Illustrated Parts List - IPL Update

372 XP X-TORQ

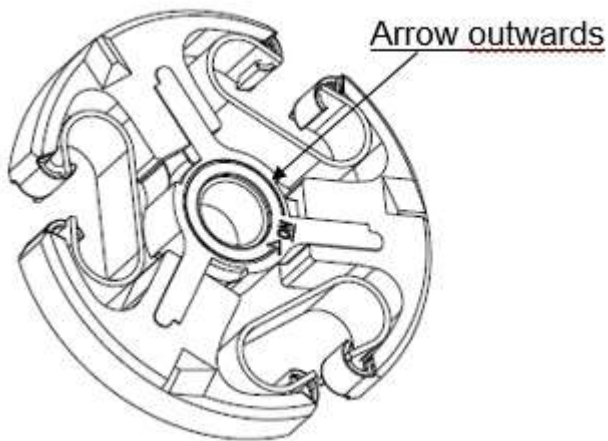
1. New Ignition module. Component update. This update does not **solve** misfire when using the decompression valve. An improvement for this will come later.
2. New clutch with higher specification.
3. Sleeve to cylinder cover. Available as separate spare part
